NUMBER: B392R1089-0

SERVICE BULLETIN

Ride: THUNDERBOLT

Subject: Double Sweep Inspection

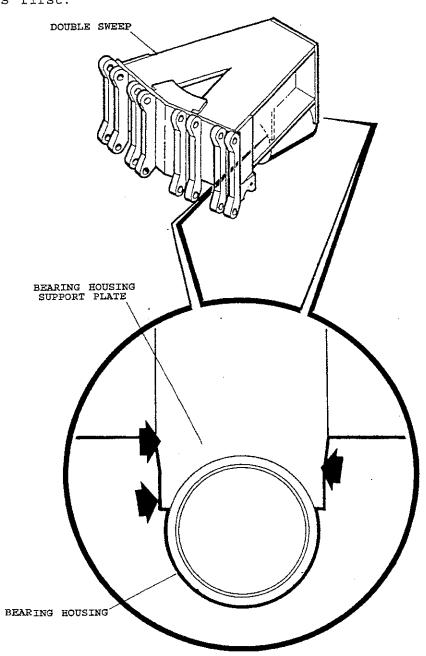
Chance Rides, Inc. requires all owners of THUNDERBOLT amusement rides to inspect the double sweeps for cracks around the bearing housing support plates. Inspection must be done as shown in the illustration on this bulletin. If the plate cracks, failure of the part could occur, resulting in possible injury to passengers.

- Thoroughly clean all areas to be inspected. All areas must be free of grease and other foreign materials which could hamper inspection.
- 2. Visually inspect all areas as indicated on the illustration below.
- This inspection must be done every 30 days or at each set up, whichever occurs first.

If any cracks are found, contact the Chance Rides Customer Service Department. DO NOT ATTEMPT TO REPAIR OR WELD. DO NOT OPERATE the ride until the Chance Rides, Inc. approved repair rework kit number K392R1089-0 has been properly installed. If no cracks are found during inspection, the kit is not required.
